# UNITED STATES PATENT AND TRADEMARK OFFICE

APPLICATION NO.	FILING DATE	FIRST NAMED INVENTOR	ATTORNEY DOCKET NO.	CONFIRMATION NO.
10/680,069	10/06/2003	Tuoc Tan Nguyen	816020-100050-US	9948
34026	7590	05/03/2005	EXAMINER	
JONES DAY 555 WEST FIFTH STREET, SUITE 4600 LOS ANGELES, CA 90013-1025			MILLER, CHERYL L	
			ART UNIT	PAPER NUMBER
			3738

<b>Office Action Summary</b>	Application No. 10/680,069	Applicant(s) NGUYEN ET AL.	
	Examiner Cheryl Miller	Art Unit 3738

## DETAILED ACTION

Patent Application Publication Feb. 27, 2003 Sheet 2 of 13

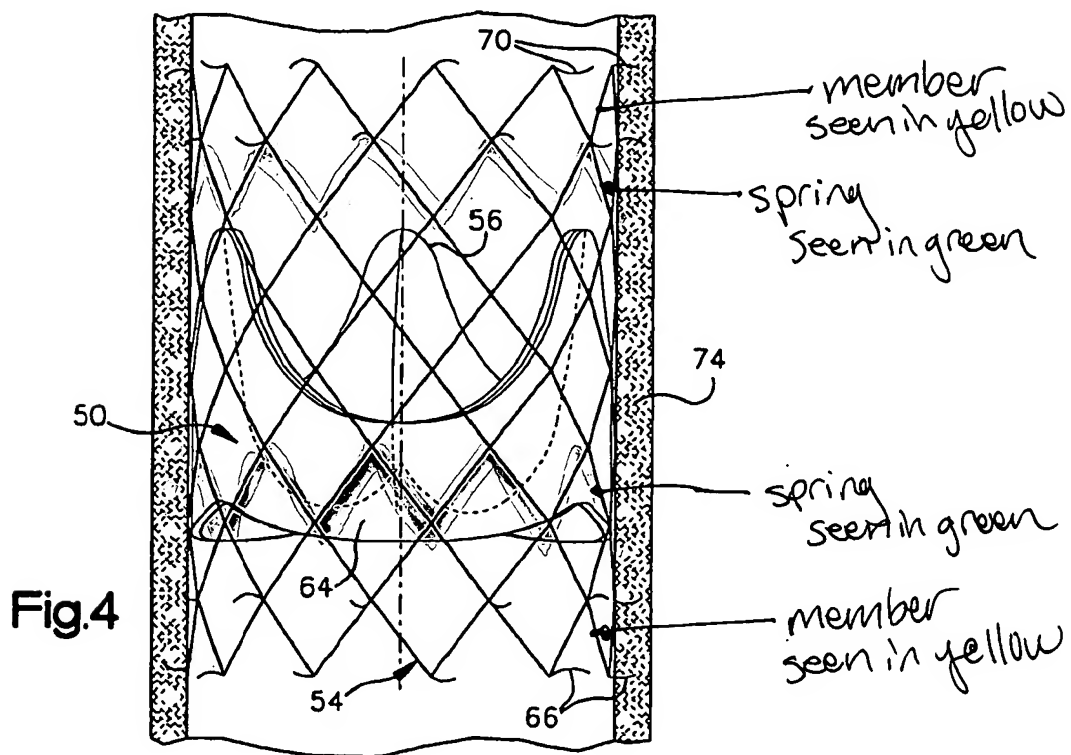
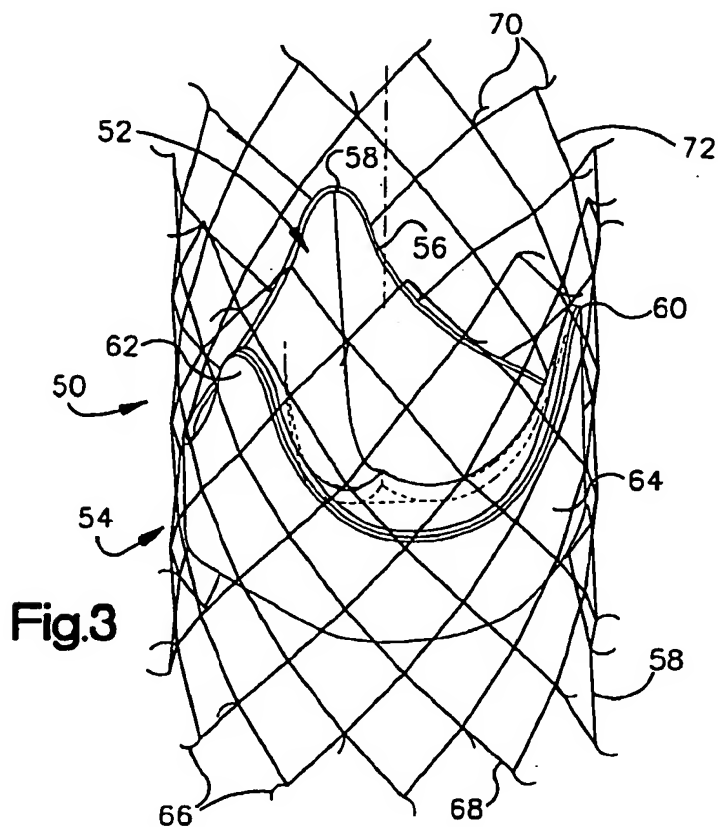
Claims 1-2 and 5-6 are rejected under 35 U.S.C. 102(e) as being anticipated by Gabbay (US 2003/0040792 A1). Gabbay discloses a valve assembly (fig.2, 4, 14) comprising a replacement valve (12, 52, 472) having a scalloped inflow annulus (seen as slightly scalloped in fig.4, 15, 24, 25; and disclosed to scallop, [0042]), an outflow annulus, and a plurality of leaflets (22, 24, 26), and a spring aided anchoring structure (14, 54, 420) comprising a plurality of members (members may be considered a ring strut seen in fig.4, attachment 1, or linear members 406, 428, seen in attachment 2) and a plurality of springs therebetween (springs may be considered to be ring stents positioned between end stents, seen in attachment 1, the stents having spring properties 0048, 0049; or spring coils 408, 430 in attachment 2). Gabbay discloses the valve (12, 52, 472) positioned internal of the anchoring structure (14, 54, 420). Gabbay discloses the members (struts in attachment 1 or 2) to comprise peaks and valleys. Gabbay discloses the assembly to comprise anchoring sections (this could be any portion along stent, or could be barb 66, or flare sections on stent).
